CITY OF ALBUQUERQUE

August 26, 2020

RE: **Lot 14 Block 2 Unit 22 SAD 228
6311 Camino Alto NW
Volcano Cliffs Subdivision
Grading and Drainage Plan
Engineers Stamp Date 8/22/2020 (D10D003C14)**

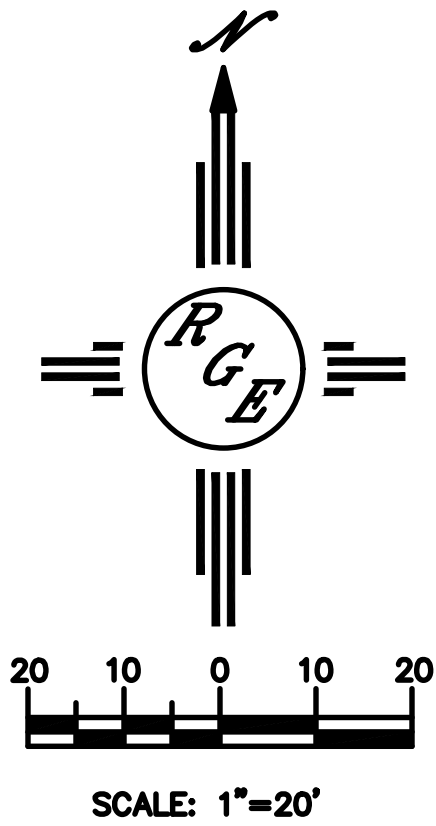
Based upon the information provided in your submittal received 8/26/2020, this plan is approved for Grading Permit.

Prior to Building permit approval a Pad Certification will be required, provided by the Engineer or a registered Land Surveyor.

Advise the owner contractor not to use dirt as a ramp to climb the curb, use lumber or crusher fines for this purpose.

Reiterate to the Owner/Contractor that a separate permit for a garden/retaining wall must be obtained with the approved G&D plan and Pad Certification. Also, if a swimming pool is to be placed the grading and drainage plan will change and will need to be resubmitted.

Prior to Certificate of Occupancy release, Engineer Certification per the DPM checklist is required.
